STAFF RECOMMENDATION 2034 10th Avenue South May 17, 2017

Application: New construction—addition and outbuilding
District: Waverly-Belmont Neighborhood Conservation Zoning Overlay
Council District: 07
Map and Parcel Number: 10513026200
Applicant: Chad Fair
Project Lead: Melissa Baldock, melissa.baldock@nashville.gov

Description of Project: Application is to construct an addition to the non-contributing house and to construct a Detached Accessory Dwelling Unit (DADU). The addition will add a new front porch to the house and will alter and extend the roof.

1 Copy of Left
1/8" = 1'-0"

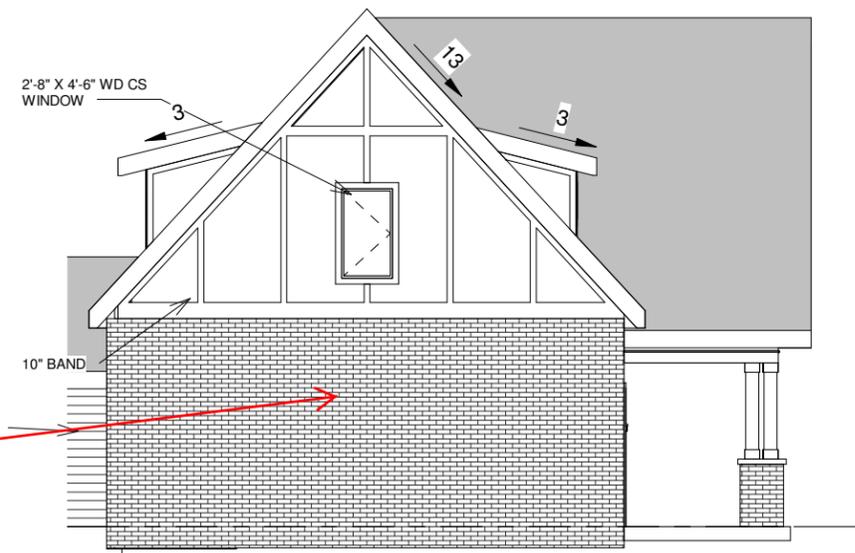
MHZC Note:
existing window to remain

② H - Right
3/16" = 1'-0"

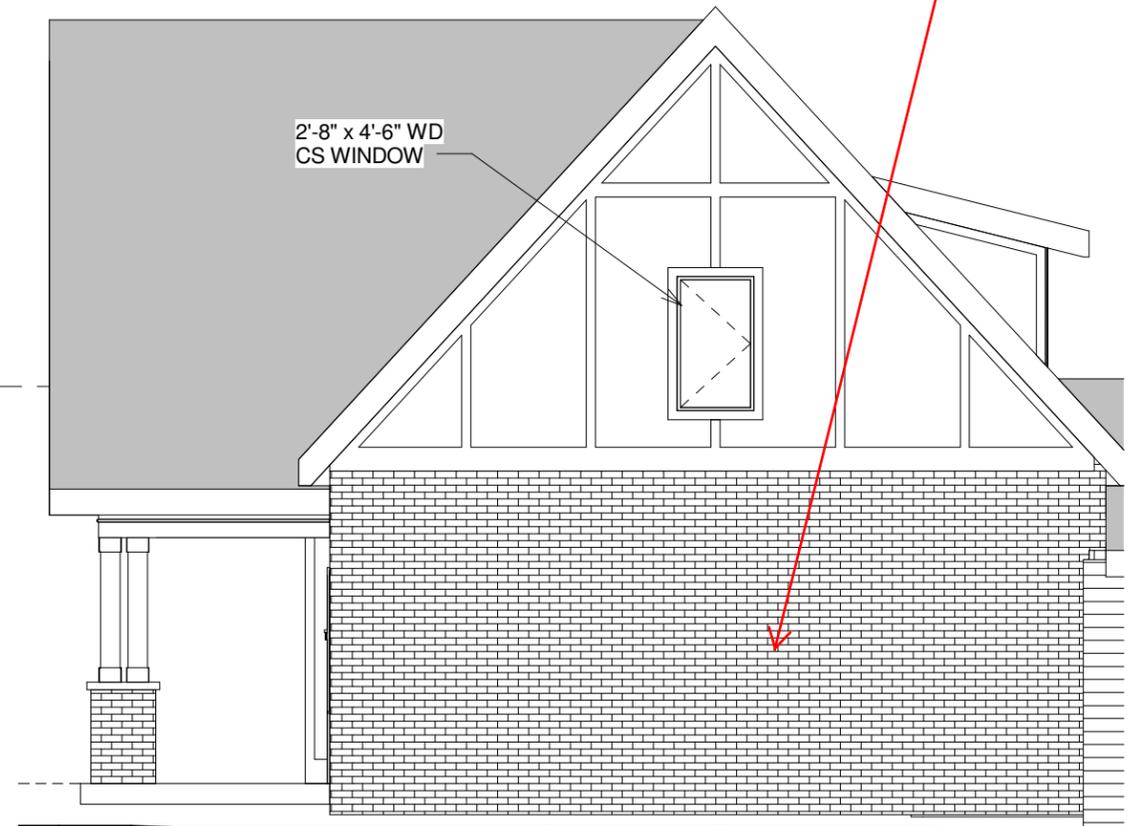
MHZC Note:
existing door to be
removed and
bricked in
